Supplementary Report: Application for One Variance, Subject to Three Conditions, Respecting One Third Party Electronic Ground Sign - 3493 Kingston Road

Date: August 28, 2025

To: Sign Variance Committee

From: Project Director, Business Transformation and Citywide Priorities, Toronto Building

Figure 5: Map 23 Land Use Plan – 3493 Kingston Road

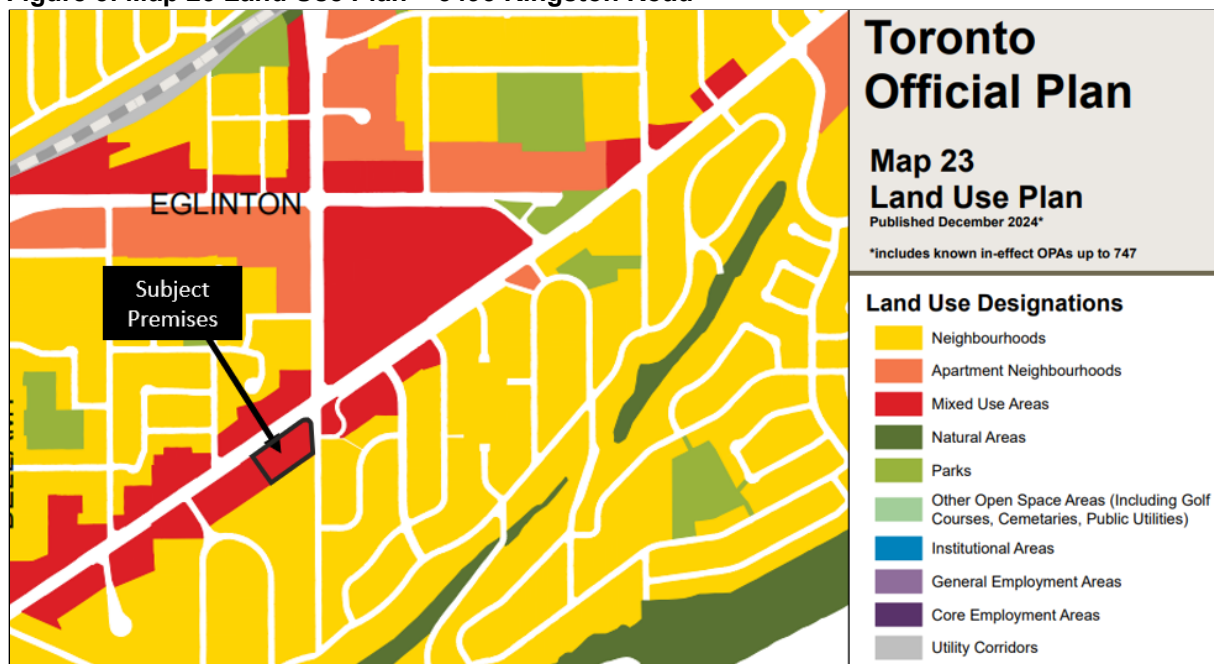
The Official Plan land use designation for the property at 3493 Kingston Road and surrounding lands to the north, east and west is Mixed Use (see Figure 5). Mixed Use Areas are intended to promote a balanced and dynamic community by accommodating diverse needs through a combination of commercial, residential, institutional, and open space uses, similar to the uses currently identified on the area. The Subject Premises houses three low-rise commercial buildings, aligning with the Sign District and the Official Plan designations for the property.

Submissions indicate that the Proposed Signs align with Sections 2.2.2, 2.3.1, 3.1.1 and 4.5.2 of the Official Plan and Urban Design Guidelines as they would: enhance the public realm; be contextually appropriate due to the modest size and scale; be located within active commercial areas; respect neighbourhood character through context-sensitive design; support economic vitality by providing advertising space for local businesses and events; and mitigate land use conflicts, with no adverse effects on adjacent uses.

Figure 6: Dispersion of Light Diagram - Original Proposed Sign (from Submissions)

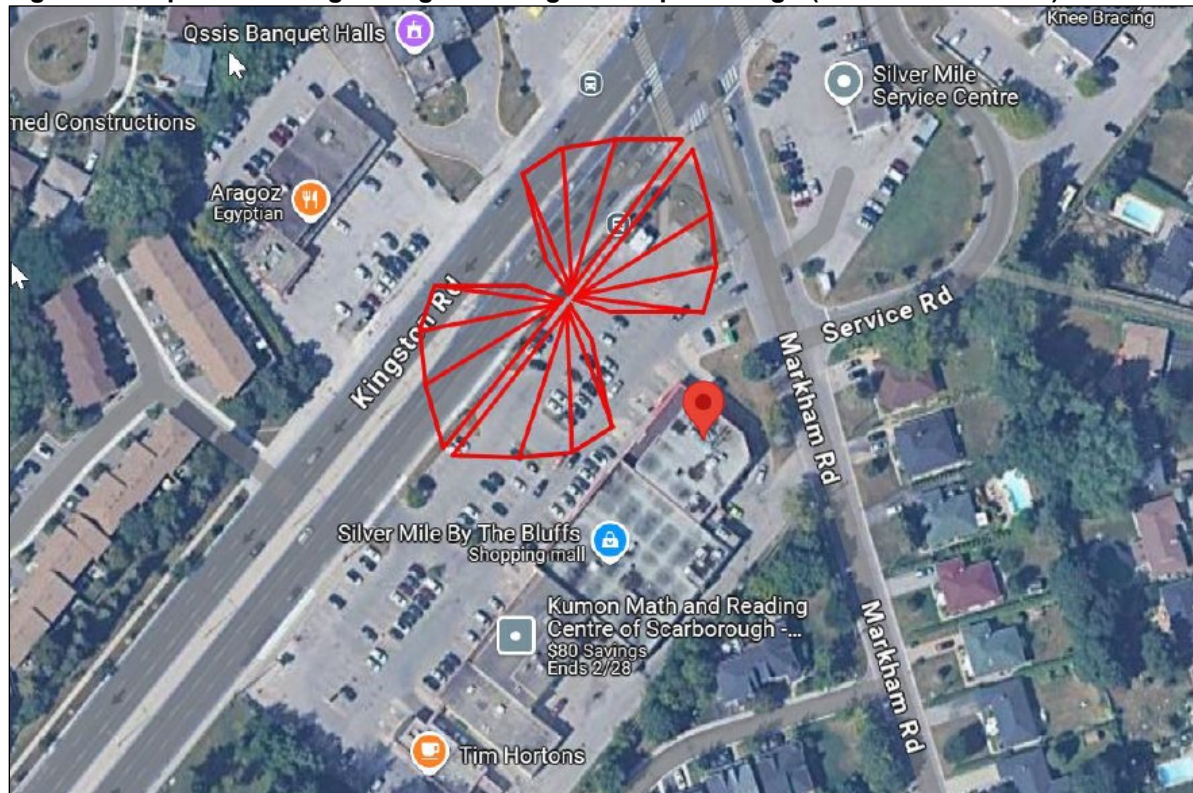
The Applicant has submitted evidence demonstrating that the impactful light emitted by the electronic static displays, operating at the maximum brightness of 300 nits permitted under the Sign By-law, would reach approximately 50 metres. At this distance, the light intensity becomes comparable to that of a full moon, which the Applicant identifies as the threshold below which light impact is considered negligible. They assert that any light emitted beyond the defined light shed cone, illustrated in Figures 6 and 7, would fall below this threshold.

As a result, neither the Original Proposed Sign or the Alternative Proposed Sign are expected to result in light trespass into adjacent residential properties along Kingston Road or Markham Road.

Figure 7: Dispersion of Light Diagram - Alternative Proposed Sign (from Submissions)

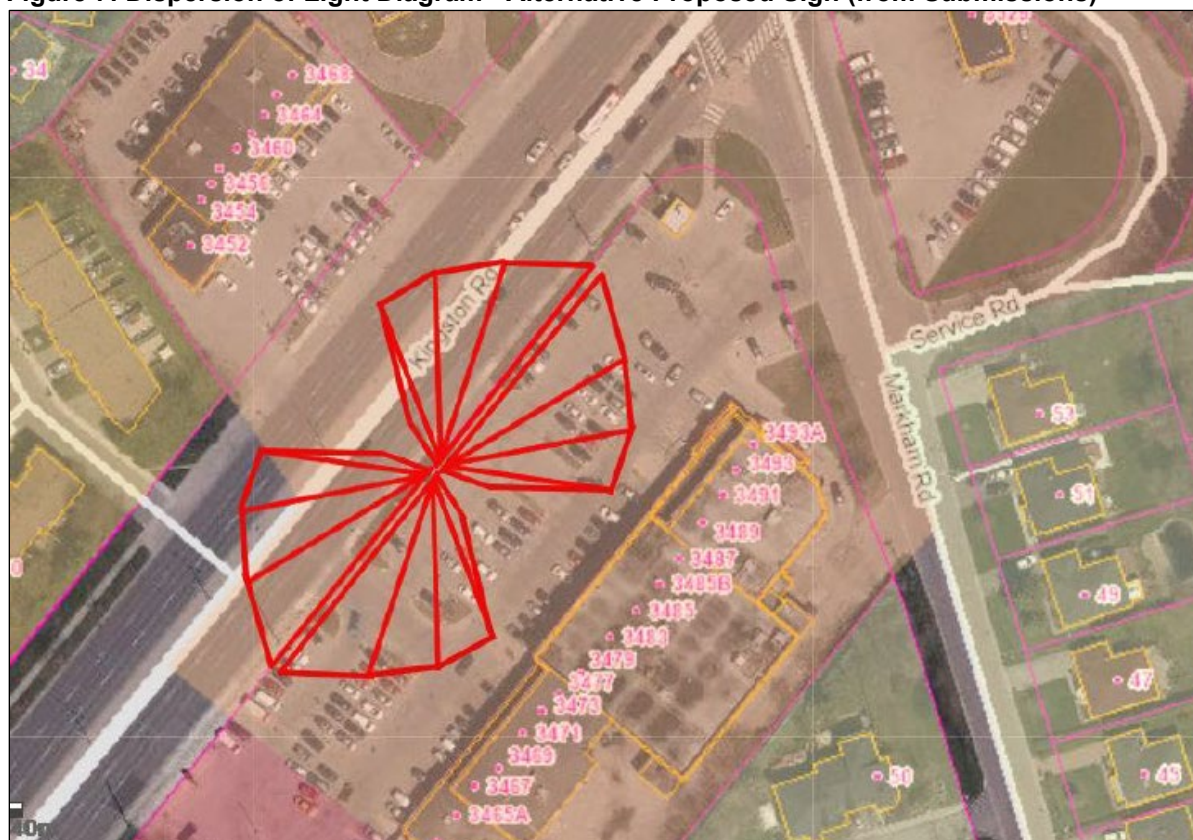
Although the Alternative Proposed Sign is sought to be placed at approximately 45 metres from an RA district, the Applicant contends that the nearest residential building is approximately 58 metres away, therefore light emissions are not expected to affect the property. This area is also buffered by a fence of similar height to the Proposed Signs and mature trees, which would further prevent light trespass and visual exposure.

Staff agree that, based on the details provided in the submissions and subject to conditions regarding size, height and orientation, the illumination impacts of the Original Proposed Sign or the Alternative Proposed Sign on the nearby residences should be minimal.

Figure 8: Location of Existing Signs in relation to the Original Proposed Sign

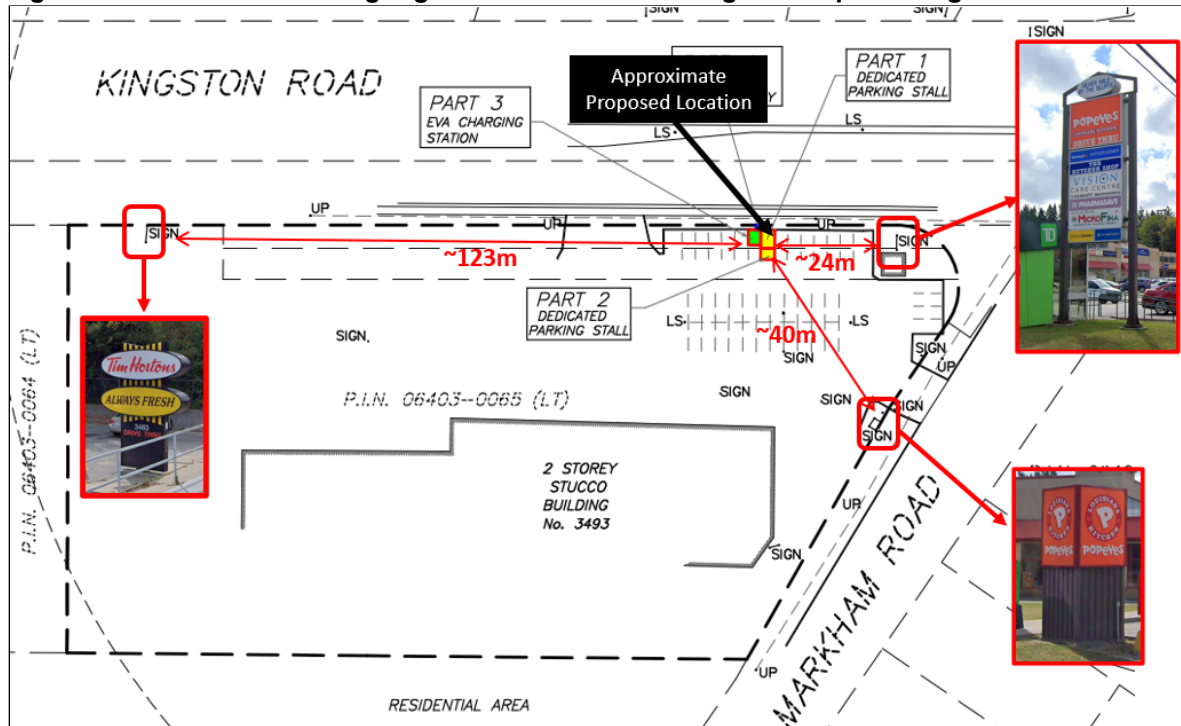
The installation of either the Original Proposed Sign or the Alternative Proposed Sign would result in a third ground sign on the same frontage. Moreover, the Original Proposed Sign, located approximately 24 metres from the existing Multi-Tenant Sign (refer to Figure 8), falls significantly short of the required separation distance, contributing to concerns regarding visual clutter and cumulative signage impact. In response to these concerns, as identified in the June staff report, the Applicant has proposed an alternative location for the sign, resulting in the Alternative Proposed Sign.

Figure 9: Location of Existing Signs east of the Alternative Proposed Sign (from Submissions)

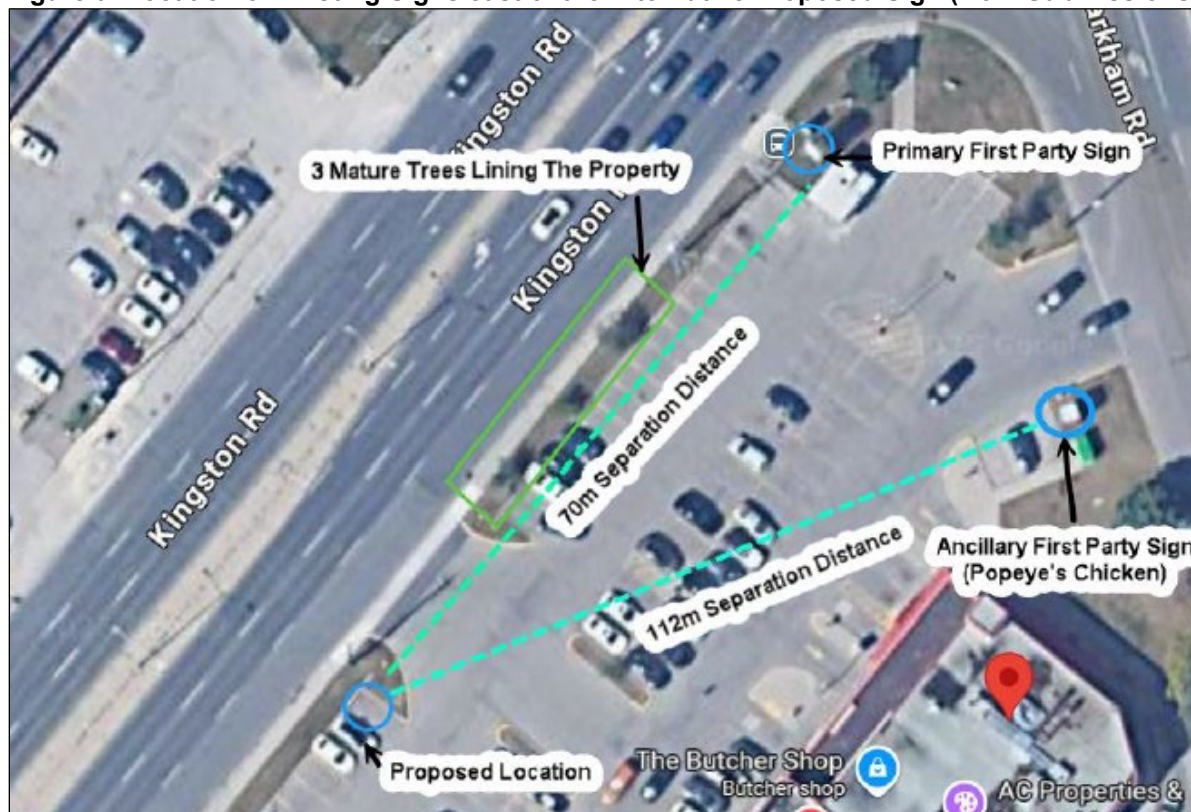
Staff is of the opinion that the Alternative Proposed Sign presents a lower degree of incompatibility relative to the Original Proposed Sign, however, it still does not fully resolve concerns regarding sign clutter. The potential of multiple sign faces being visible simultaneously, the use of electronic copy on a ground sign of the third party sign class (both prohibited in CR sign districts), and the cumulative number of signs on the same frontage and across the Subject Premises continue to contribute to the issue.
